PROJECT:	Nebraska State Patrol Crime Lab	PROJECT NO.	#L13459
FROM:	BVH Architects	DATE:	7/11/14
TO:	Bidders	ADDENDUM NO.	#2

ADDENDUM NO. CC-2

Nebraska State Patrol Crime Lab
Lincoln, Nebraska - 2014
OA Project No. 014/A14-0651

3. Sheet E2.2-TI, Enlarged Power Plans – Area A, Area D – Tenant Improvement

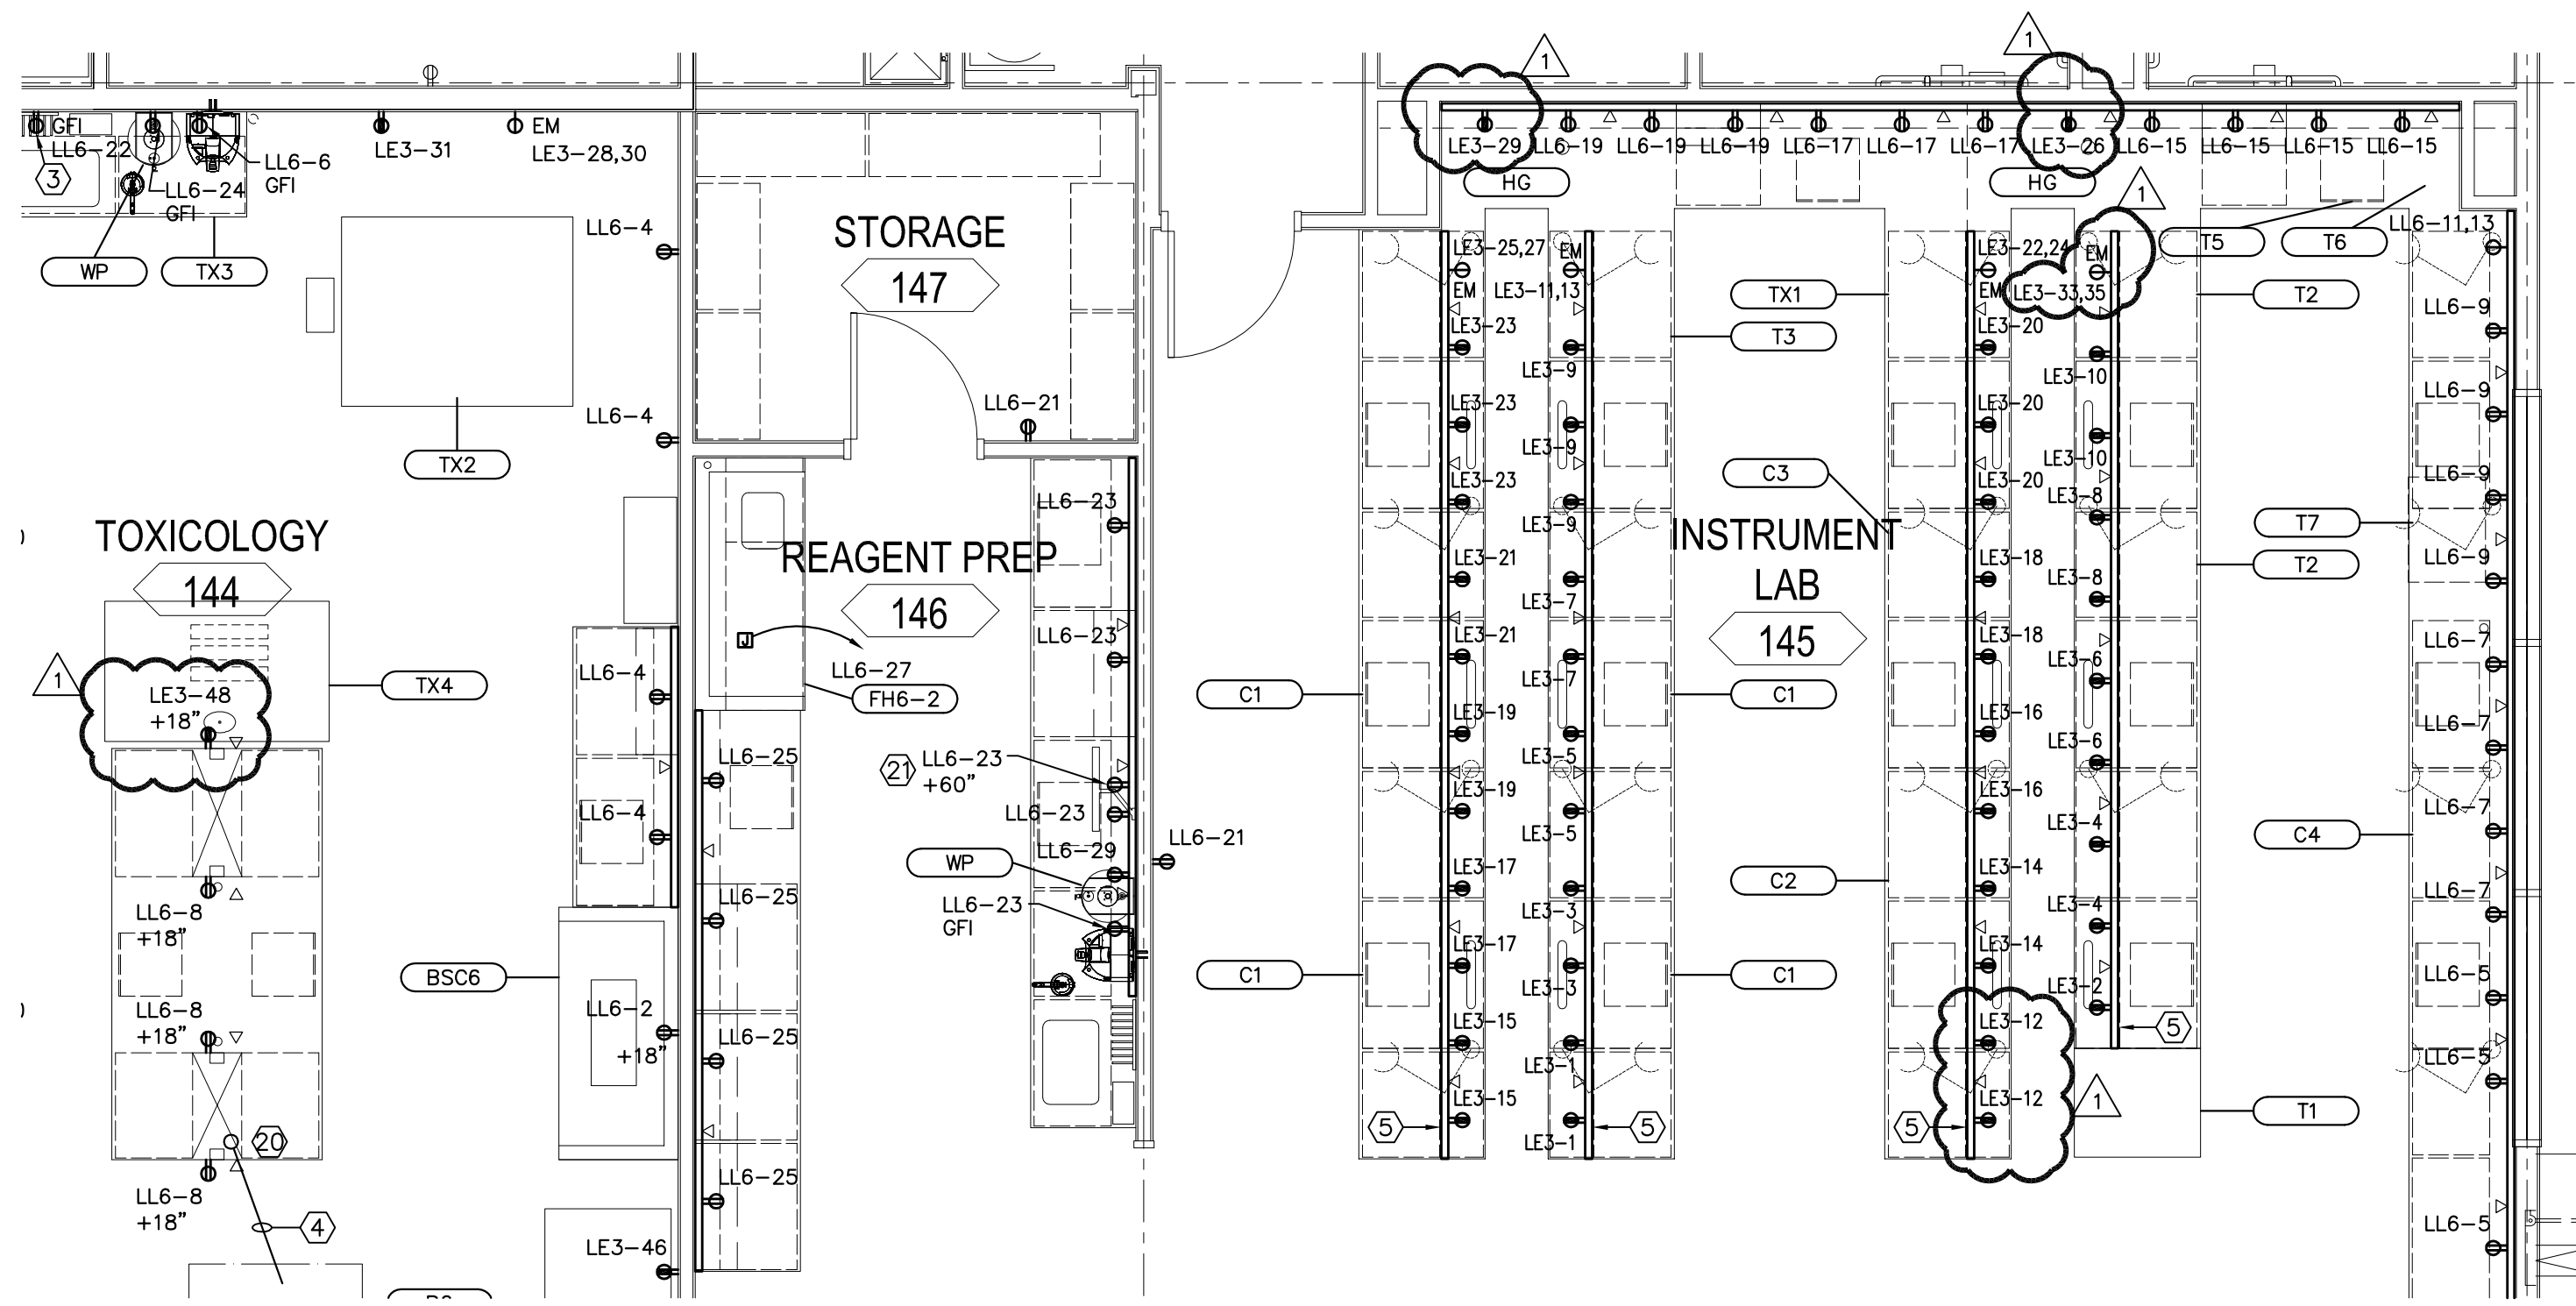
- a. Enlarged Power Plan – Area D, Mech 149, VFD fed from circuit “H2-2,4,6” shall be serving “EF-3” in lieu of “EF2”.

ENLARGED POWER PLAN - AREA C - TENANT IMPROVEMENT

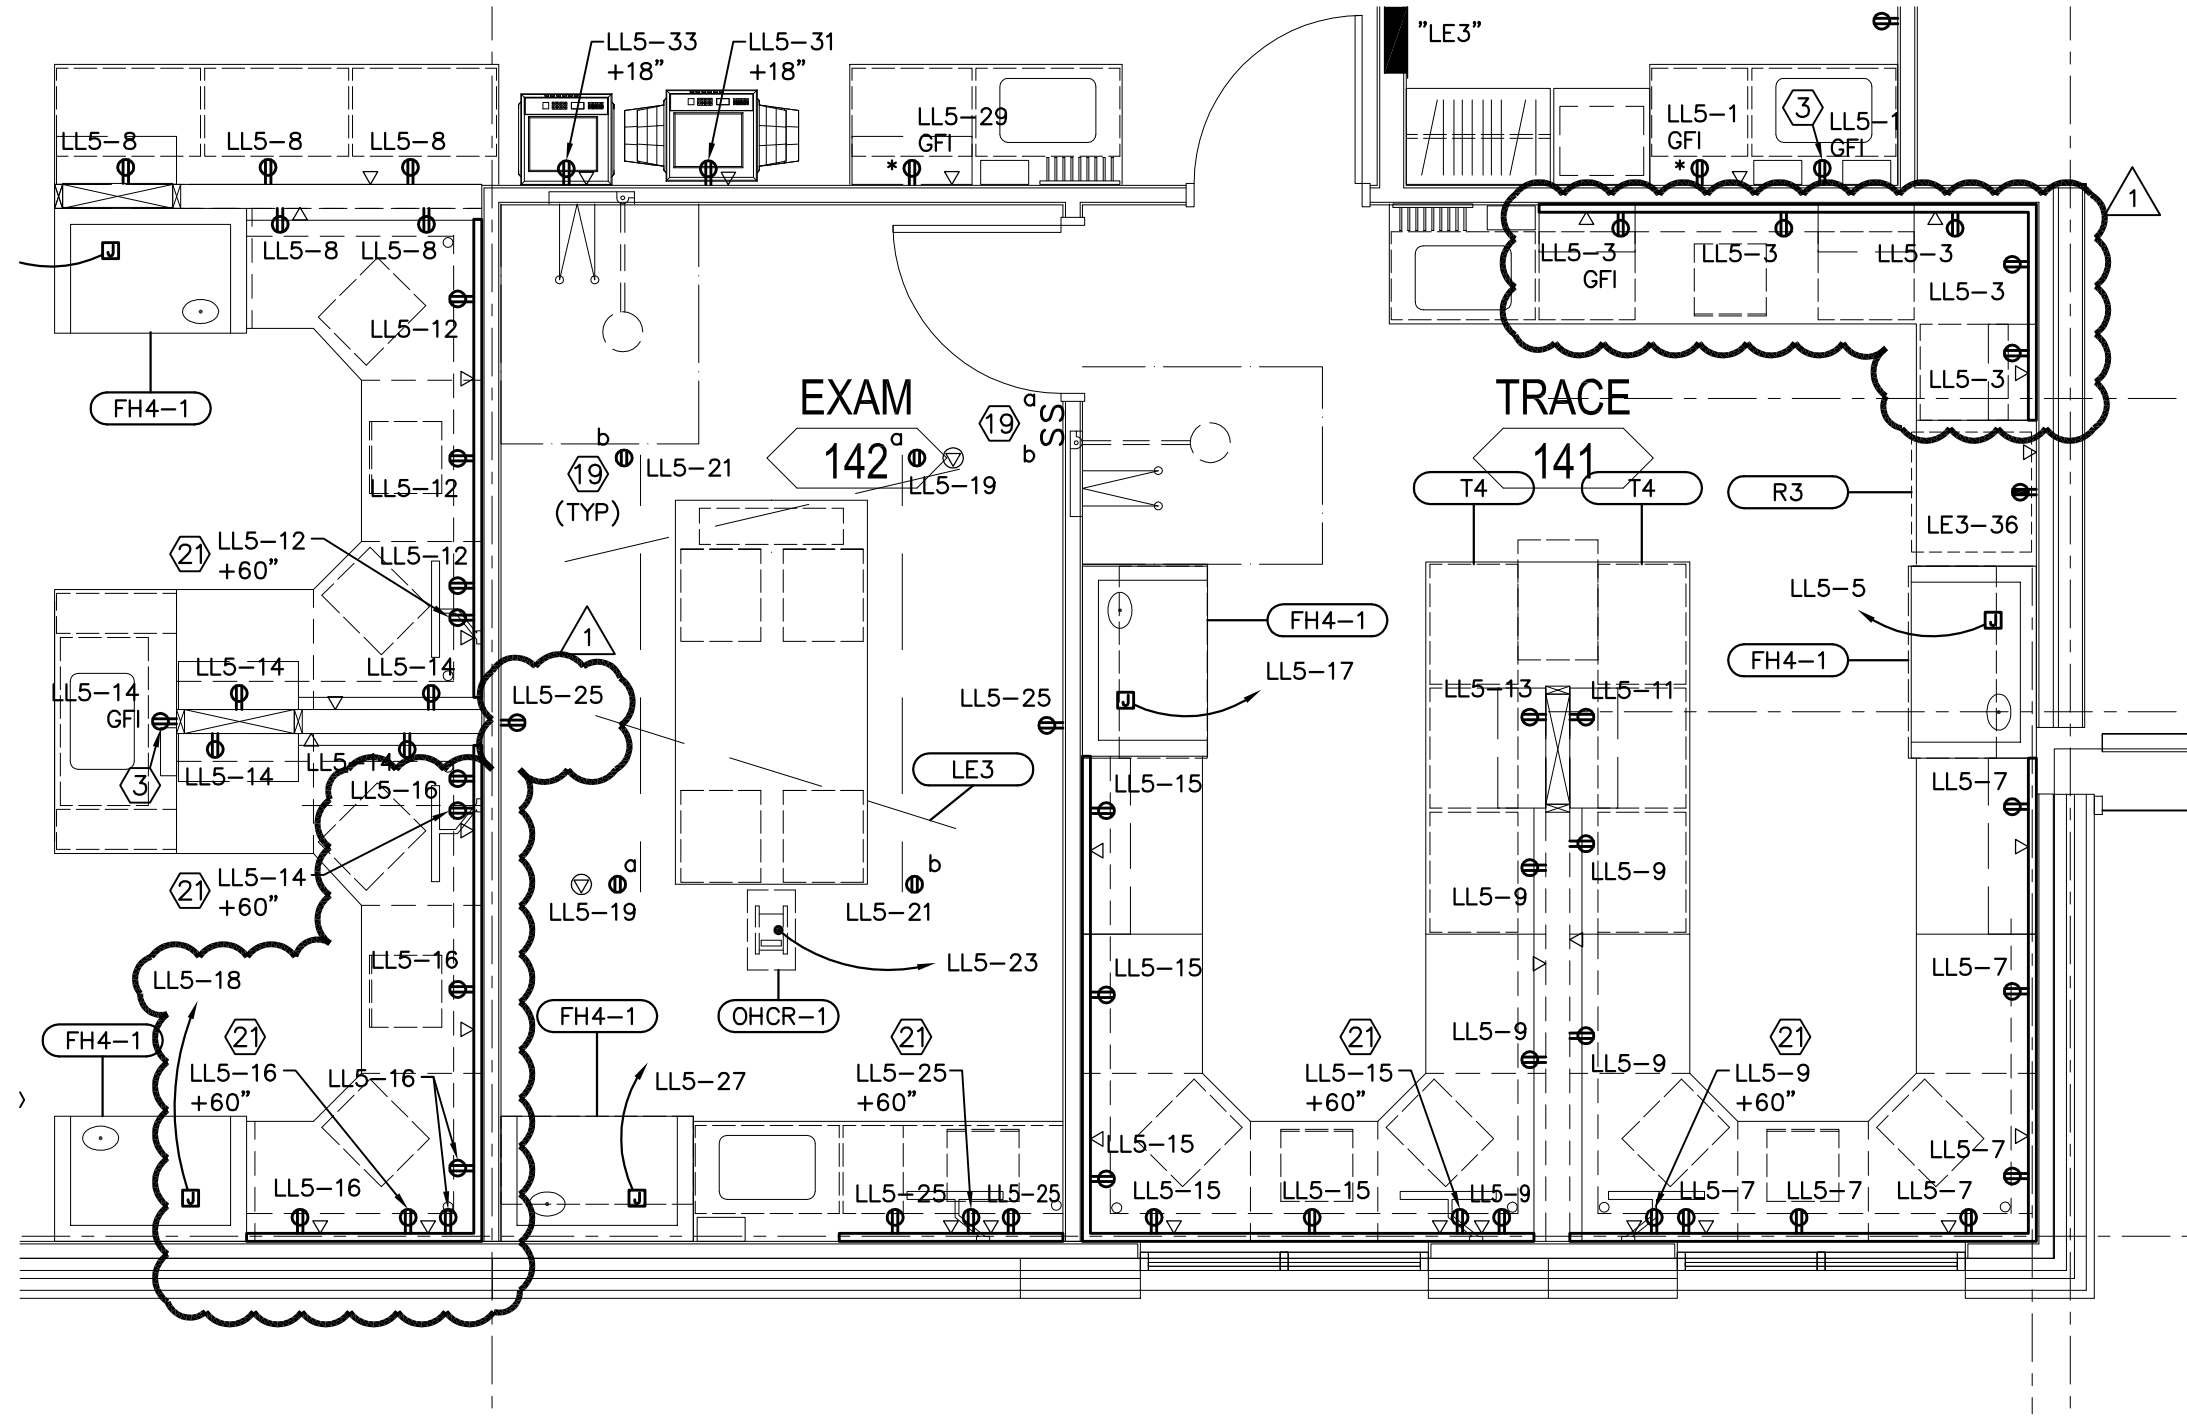
5. Sheet E2.4-TI, Enlarged Power Plan – Area C – Tenant Improvement
 - a. Trace 141, receptacles being fed from circuit “LE3-3” should be fed from circuit “LL5-3”. Refer to attachment E2.4-TI-2 to Addendum No. 2, dated July 11, 2014.

- b. Exam 14, receptacle on west wall shall be fed from circuit LL5-25.
 - c. Controlled Substances 143, revise receptacle circuits as shown in attachment E2.4-TI-2 to Addendum No. 2, dated July 11, 2014.

- d. Toxicology 144, receptacle serving equipment “TX4” shall be fed from circuit “LE3-48” in lieu of “LE1-48”.
 - e. Instrument Lab 145, revise receptacle circuits as shown in attachment E2.4-TI-1 to Addendum No. 2, dated July 11, 2014.
